**Amendments to the Drawings:**

### **REMARKS**

ANNOTATED SHEET  
TO SHOW  
CHANGES MADE

Figure 4

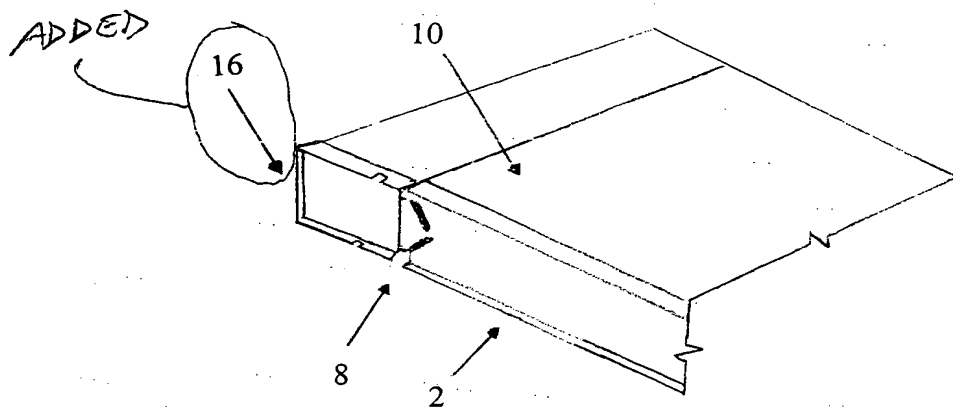
The specific changes which have been made to Figure 4 is to add item "16" to the figure.

For better clarity, claim 1 now recites a header tank, as conventionally forms part of a heat exchanger, e.g., a condenser or radiator, as disclosed in the application. Fig. 4 has been amended to generally identify a header tank 16. The alternative subject matter of previous claim 2 has been split between amended claim 2 and new claims 17-19. Other preferred aspects of the invention are claimed in new claims 13-16.
